**RE:** Petitioner #1544 -- LSE Pyxis LLC ("Lodestar") for a Declaratory Ruling that No Certificate of Environmental Compatibility and Public Need is Required for the Construction, Operation and Maintenance of Solar Photovoltaic Facility in Norfolk, Connecticut

PETITION NO. 1544

**PETITIONER LSE PYXIS LLC'S RESPONSES TO SITING COUNCIL  
INTERROGATORIES SET ONE DATED DECEMBER 2, 2022**

**Overall Site Boundary Plan**

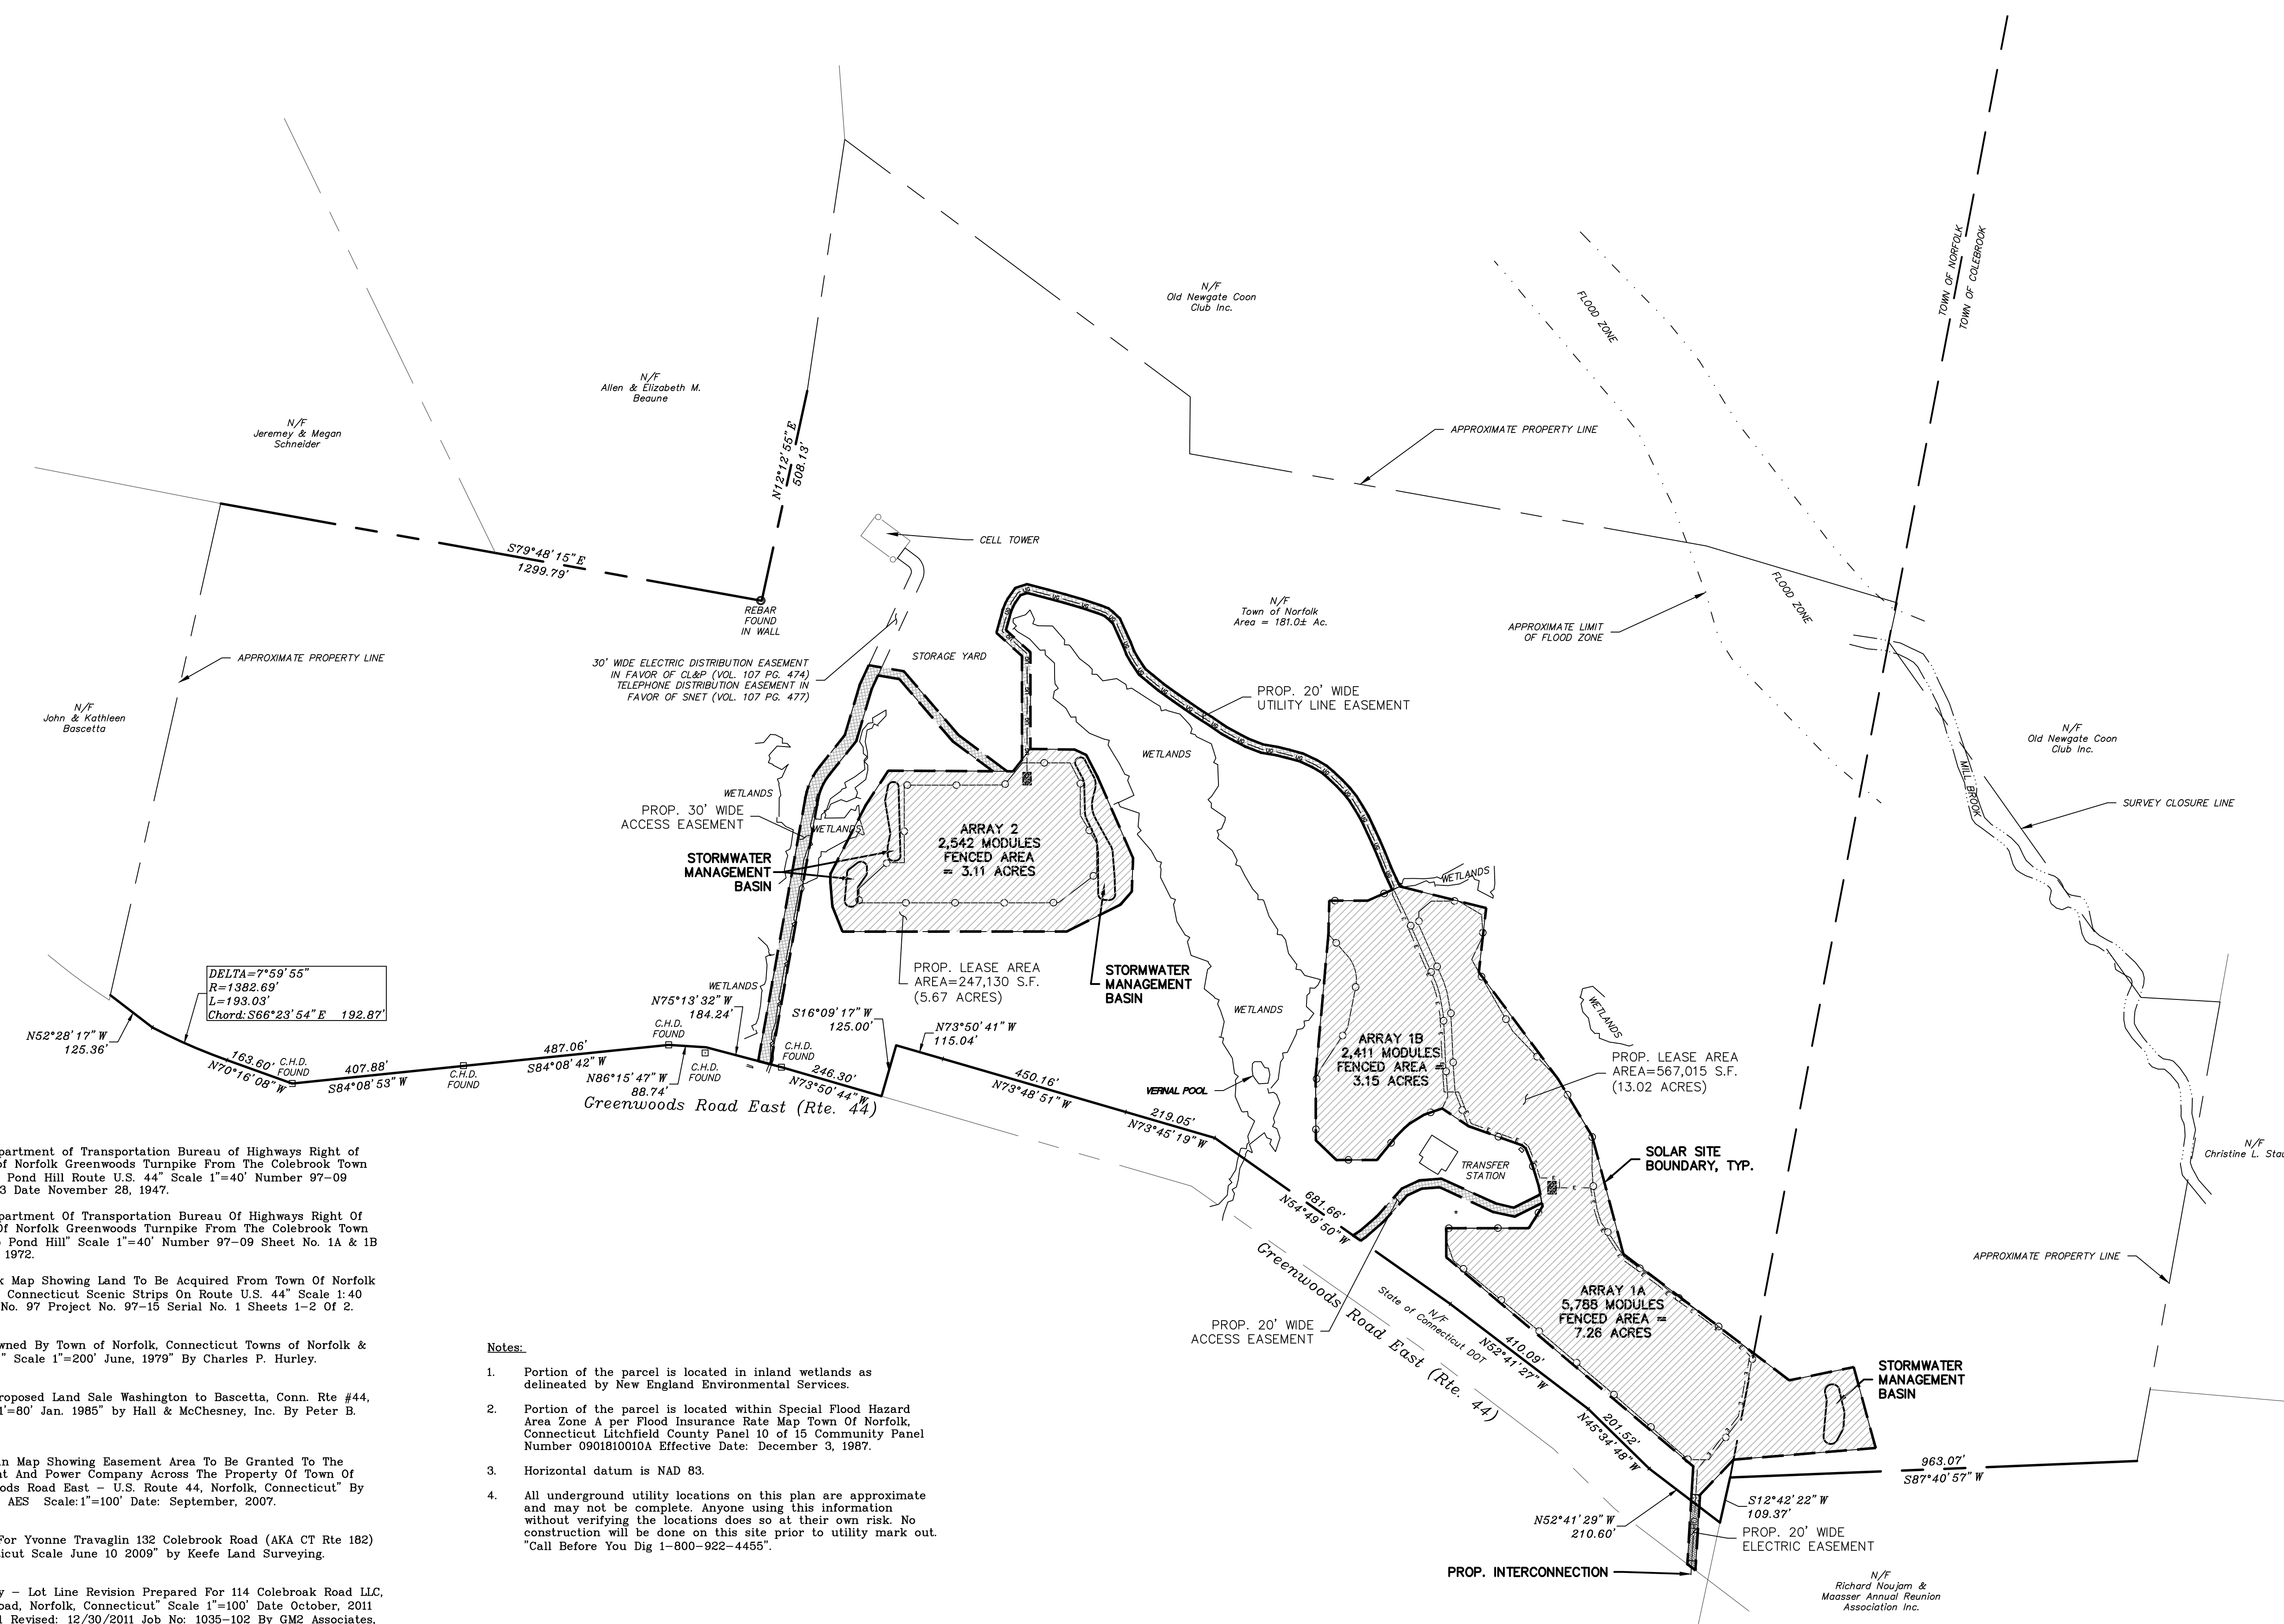
- 5. Please submit a map clearly depicting the boundaries of the solar project “site” and the boundaries of the host parcel. Under Regulations of Connecticut State Agencies §16-50j-2a(29), “Site” means a contiguous parcel of property with specified boundaries, including, but not limited to, the leased area, right-of-way, access and easements on which a facility and associated equipment is located, shall be located or is proposed to be located.*

RESPONSE: Please see Overall Site Boundary Plan attached hereto as Exhibit 1.

**EXHIBIT 2**

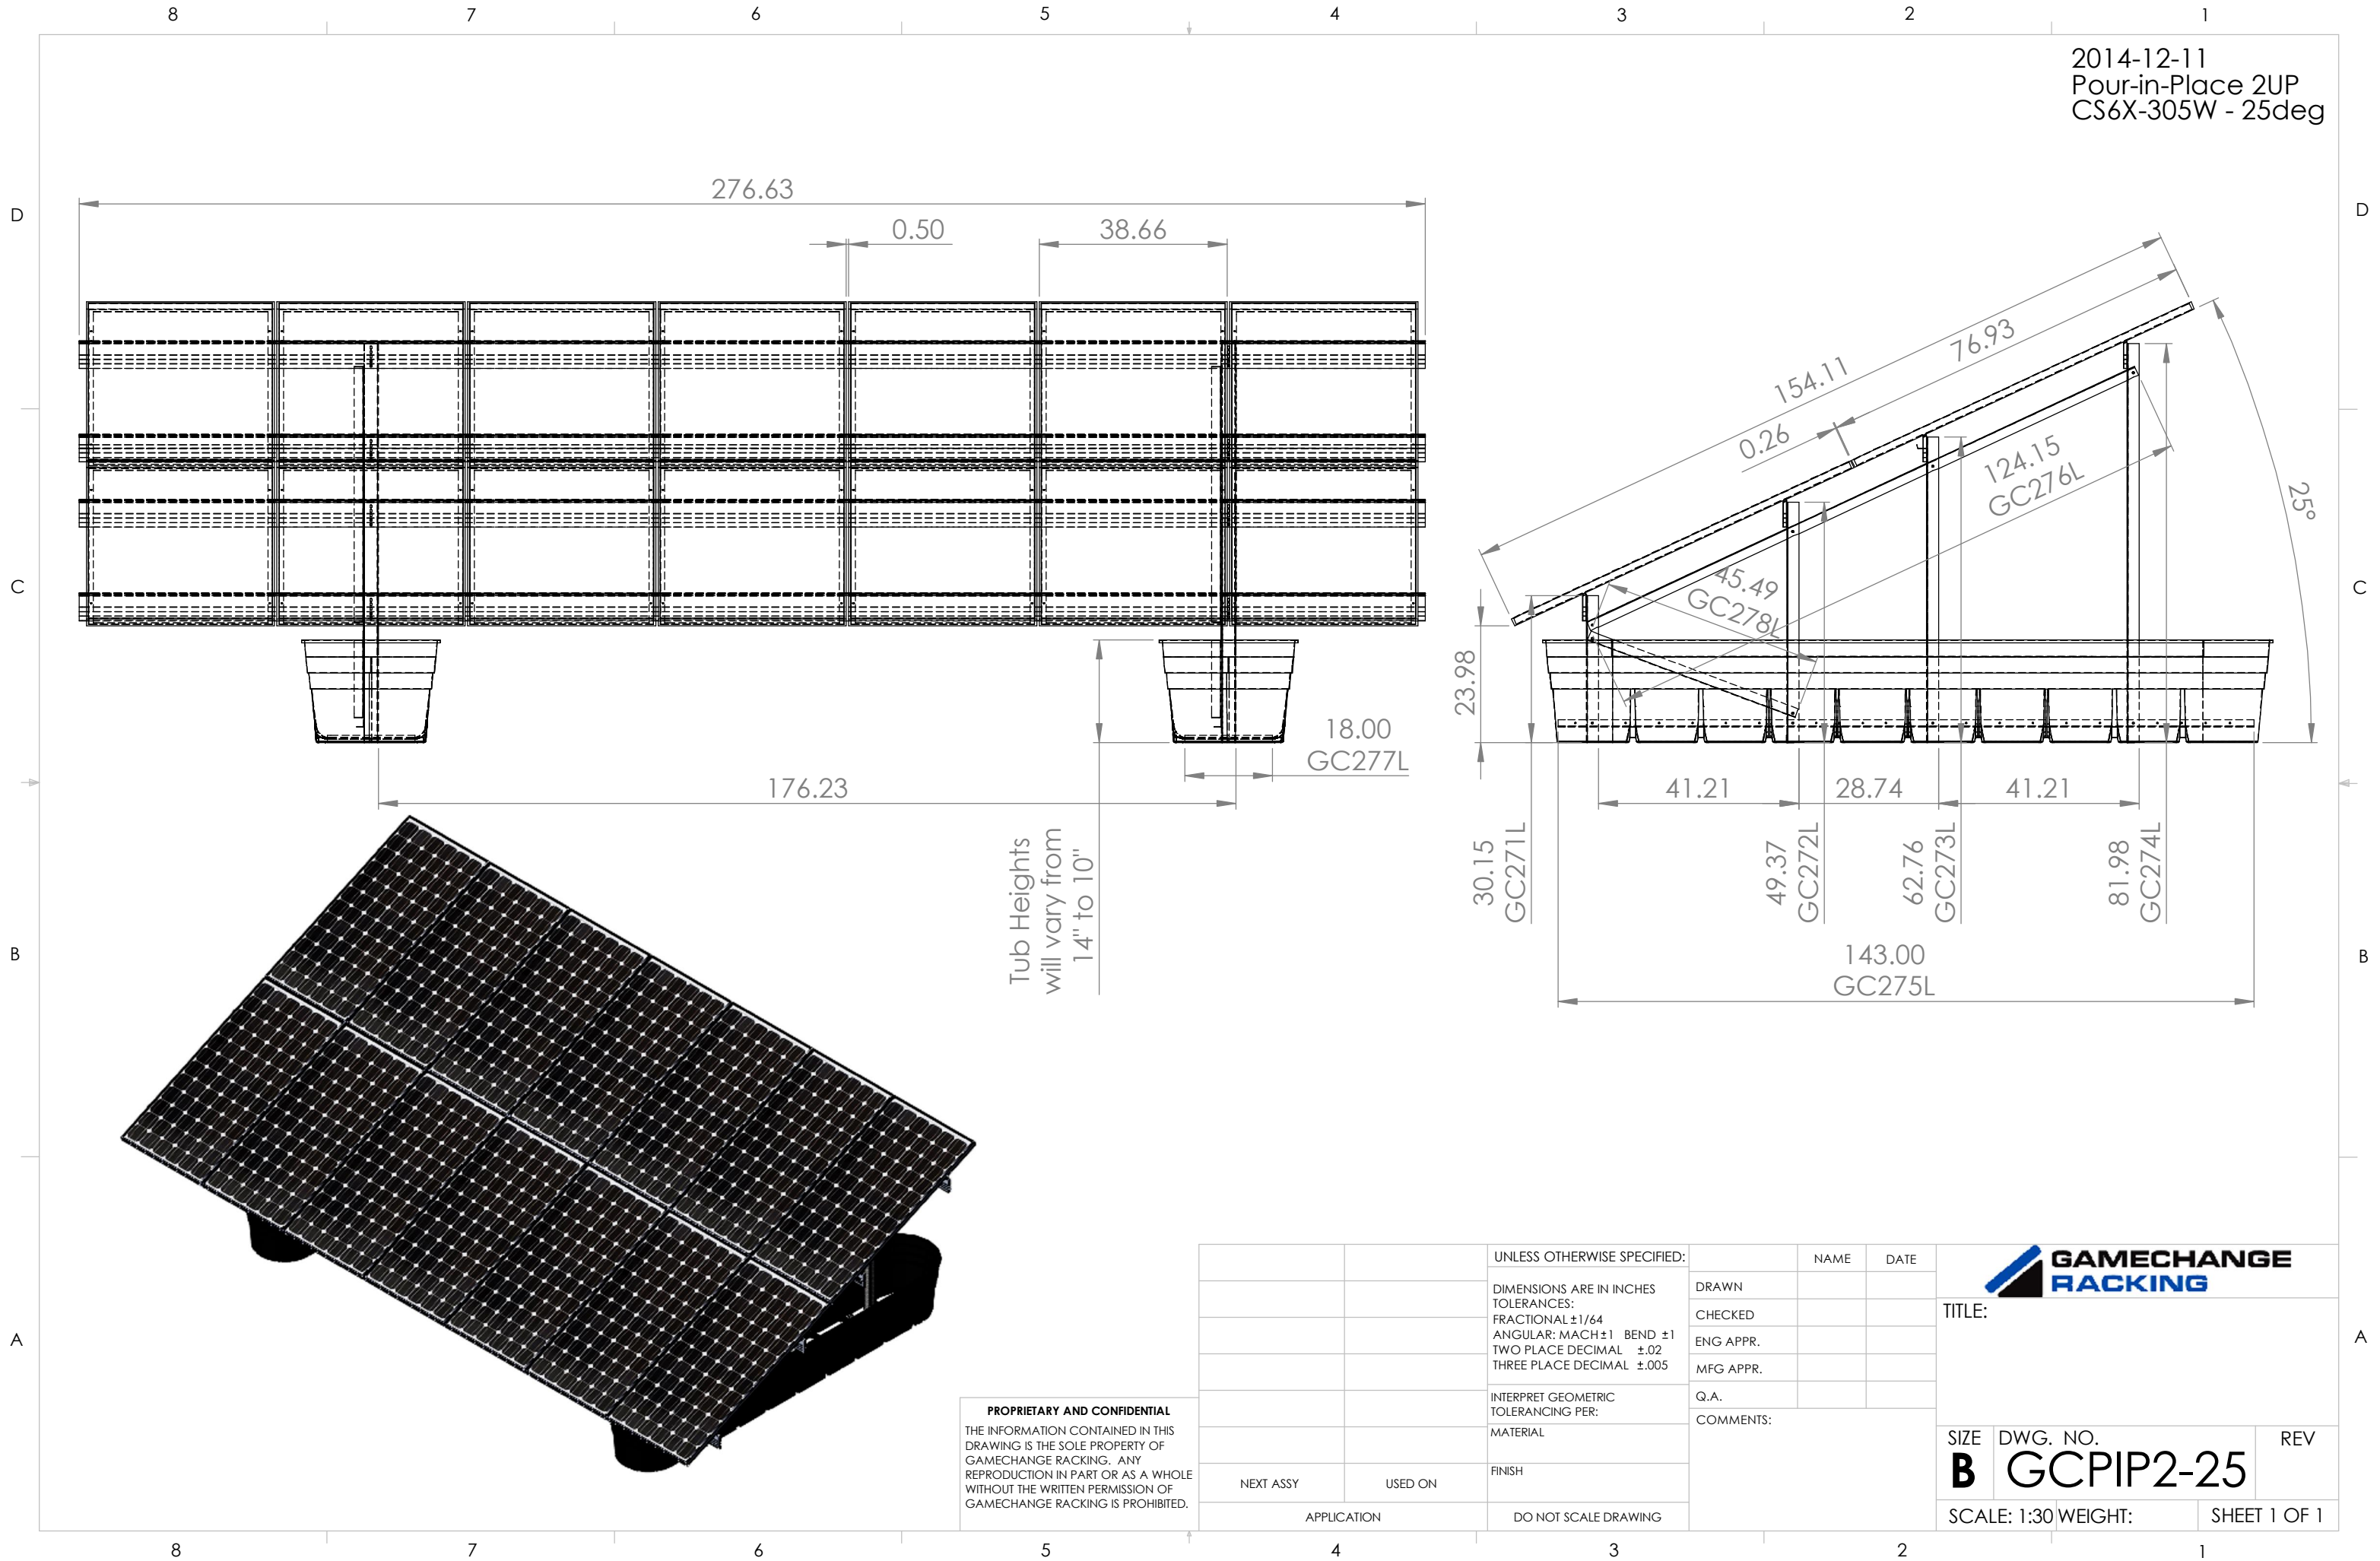
31. ***Referencing Petition Attachment 7, Stormwater Pollution Control Plan p. 13 lists impervious surfaces as a gravel road and invert/transform pads. Provide the following;***
- a. Would the ballasts supporting the solar modules and fencing in Solar Array 1A and 1B also be considered impervious? Explain.***
  - b. What is the approximate dimension of a solar array ballast and a fence ballast?***
  - c. What is the total impervious area of the solar array and fence ballasts?***
  - d. How does the presence of ballasts ensure stormwater runoff remains as sheet flow across the site?***

RESPONSE: As discussed in interrogatory 14 above, the design of the concrete ballast to support the panel racking systems has not been finalized. However, a detail of a typical ballast support is provided as Exhibit 2. This ballast is 1.5' wide x 12' long x 1.5' tall, and spaced at approximately 15' intervals. Based on this spacing, the total number of ballasts estimated for arrays 1A and 1B is 1,032. The resulting area is 18,576 square feet, a relatively small number compared to the contributing areas of the arrays (10.35 acres). The ballasts are located underneath the solar panels. As discussed in the drainage report, due to the row spacing, slopes, vegetation and other measures taken to maintain sheet flow of runoff, the panels need not be considered impervious, and the area of the panels is modeled as pervious area. For the same reasons, along with the fact that the bottom of the ballasts have grooves to allow runoff to flow under them, it follows that the ballast supports underneath the panels need not be considered impervious as well.

The support ballasts for the fence are small and not anticipated to significantly impede sheet flow across the Project. Although the support ballasts for the panel racking system

are larger, as shown on the detail provided, the bottoms of the ballasts are grooved to allow water flow under them, thus maintaining sheet flow across the site.
